Access Compliance Report

Public Rights-of-Way

Intersection ID: 23899	Main Street: CARTGATE_LN	Cross Street: STEPHENDALE_DR	Location: NE
ADA ID: 83615BDF206C	Ramp Type: PerpDiag	Initial Pass/Fail: Fail	Overall Compliance: No
Severity Score: 13.75			
Codes/Mitigation Info/Possible Solution		Field Measurements/Component Compliance

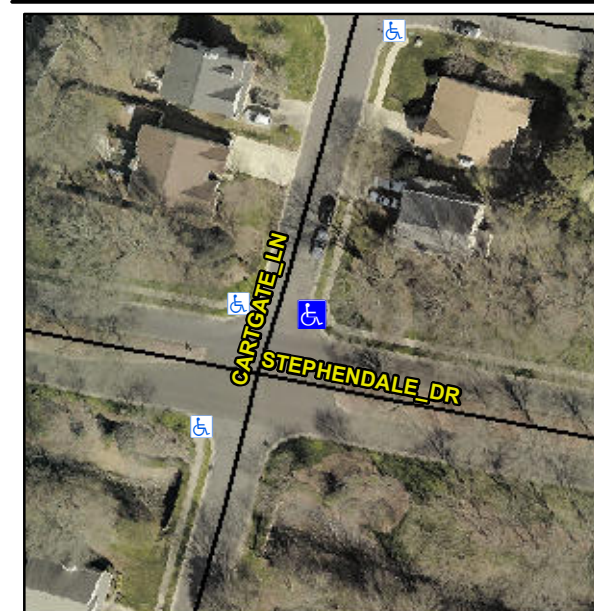
R304.2.2, R304.5.3

Compliance	Description	Data	Compliance	Description	Data
N/A	Ramp Length (in)	95.0	No	Ramp Slope (%)	9.5
Yes	Ramp Width (in)	48.0	No	Ramp XSlope (%)	3.9
N/A	Flare Type LT	N/A	N/A	Flare Type RT	N/A
N/A	Flare Slope LT (%)	N/A	N/A	Flare Slope RT (%)	N/A
N/A	Flare Traversable LT?	N/A	N/A	Flare Traversable RT?	N/A
N/A	Landing Length (in)	N/A	N/A	DWS Provided?	N/A
N/A	Landing Width (in)	N/A	N/A	DWS Contrast?	N/A
N/A	Landing Slope (%)	N/A	N/A	DWS Length (in)	N/A
N/A	Landing X Slope (%)	N/A	N/A	DWS Full Width?	N/A
N/A	Landing Curb? (Y/N)	N/A	N/A	DWS Offset (in)	N/A
N/A	Shared Landing?	N/A			
N/A	Gutter Ponding?	N/A	N/A	Gutter Slope (%)	N/A
N/A	Gutter Lip Ht (in)	N/A	N/A	Gutter X Slope (%)	N/A
N/A	Painted X Walk1?	No	N/A	Painted X Walk2?	No
	X Walk 1 Direction	To NW		X Walk 2 Direction	To SW
N/A	X Walk 1 Width (in)	N/A	N/A	X Walk 2 Width (in)	N/A
	X Walk 1 Slope (%)	0.9		X Walk 2 Slope (%)	1.4
	X Walk 1 X Slope (%)	3.6		X Walk 2 X Slope (%)	1.8

N/A	Ramp inside XWalk1?	N/A	N/A	Ramp inside XWalk2?	N/A
	Road Slope (%)	1.5	N/A	Clear Space?	N/A
	Road X Slope (%)	4.6	N/A	Clear Space to XWalk (in)	N/A
N/A	Any Obstructions?	N/A	N/A	Storm Grate/Utility Hazard?	N/A
	Obstruction Type			Storm Grate/Utility Type	
		N/A			N/A
		Yes		Surface Condition? (G/P)	Good

Remove & Replace Curb Ramp With Two New Directional Ramps or Equivalent.
